OHIO TURNPIKE AND INFRASTRUCTURE COMMISSION

ADDENDUM NO. 3

**PROJECT NO. 43-18-03
BRIDGE DECK REPLACEMENT AND REHABILITATION
U.S. ROUTE 42 OVER OHIO TURNPIKE, M.P. 161.1
CUYAHOGA COUNTY, OHIO**

DRAWINGS: REVISED PLAN SHEET PLAN SHEET 29 OF 34

FRAMING PLAN
U.S. ROUTE 42 OVER OHIO TURNPIKE
CUYAHOGA COUNTY
M.P. 161.1

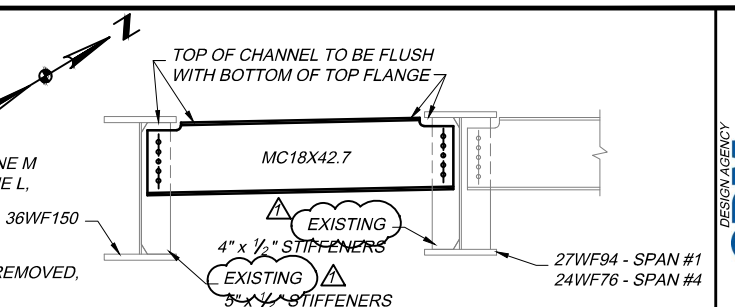
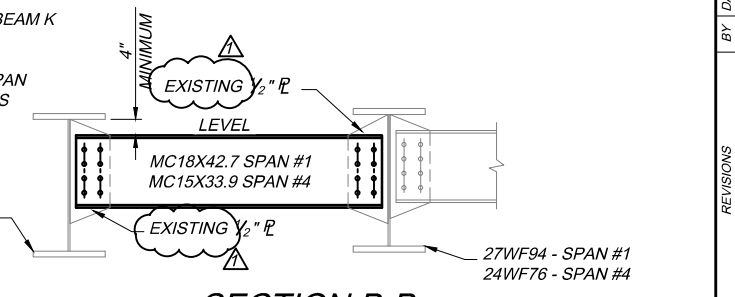
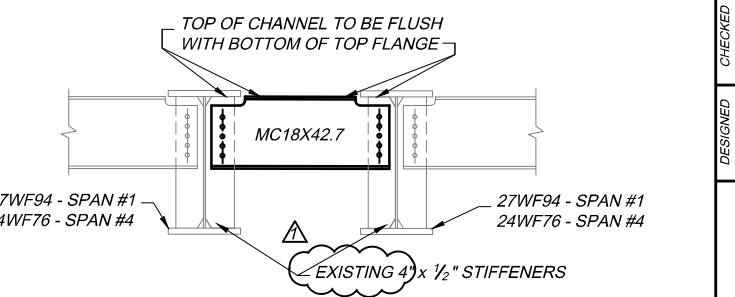
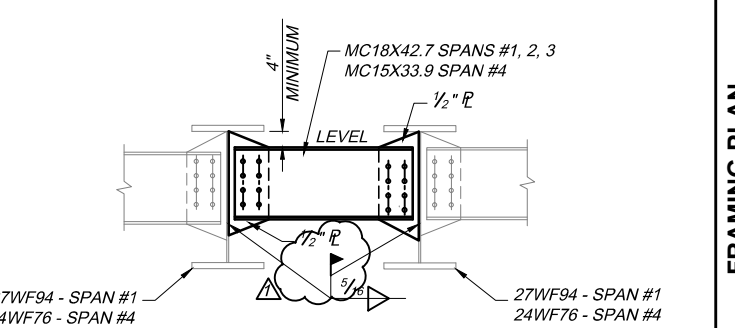
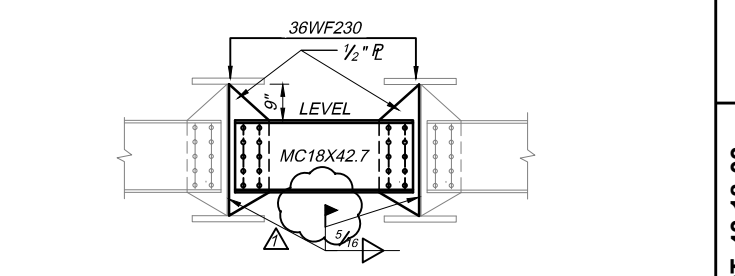
Q#21 Upon a site visit, it was noticed that there are no existing stiffeners between beams “F” & “E” other than at the bearings. It was assumed that the stiffeners were already existing and that the proposed channel diaphragms were to just be bolted to the existing stiffeners because plan sheet 29 of 34 shows a shop weld between the stiffener and the beam. Is the weight of the stiffeners included in bid items #84 & #86? Is the connection between the stiffener and beam a field weld and if so, how is the repair and painting of the existing paint system to be repaired and paid? Also, field welding of the new stiffeners to the existing beam has potential to damage the paint system on the opposite side of the web that the welding is being performed, is this to be repaired and how is this to be paid?

Q#23 Sheet 10/15 Framing plan clearly indicates shop welds in all section views A-A through E-E. Are there stiffeners already in place on beam lines E and F? Or are those included in the 513UF item?

A#21 *The welds were incorrectly identified as shop welds, and the details on Plan Sheet 29 of 34 is modified through this Addendum No. 3 to mark them as field welds. The weight of the additional stiffeners is included in Bid Items #84 and #86. If the existing paint coating system is damaged, it shall be repaired in accordance with SP 514A and shall be included in Item SP 202, Portions of Structure Removed, for payment.*

A#23 See the response to Q#21.
